STUDIO TUBULAR
 S H E L V I N G

2 Bays - 2 Shelves
 3 Front Posts
 Ceiling & Wall Mounts

Drawing # 3229

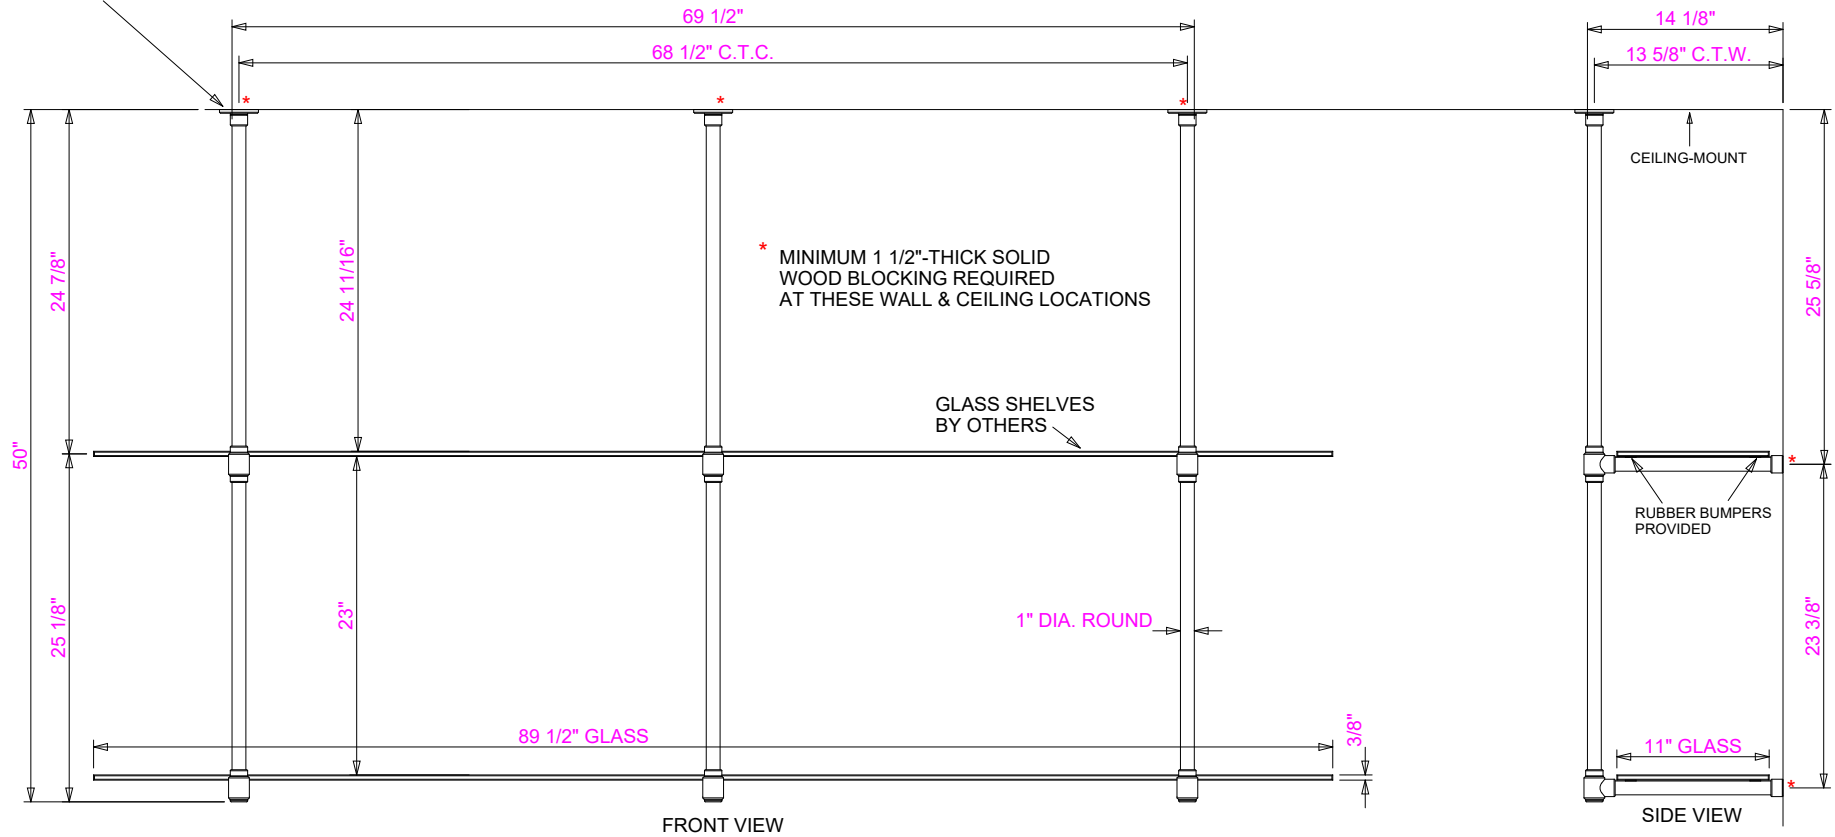
SPECIFY SCREW LENGTH REQUIRED
 TO ACHIEVE 1 1/4" MINIMUM
 ENGAGEMENT INTO WOOD BLOCKING
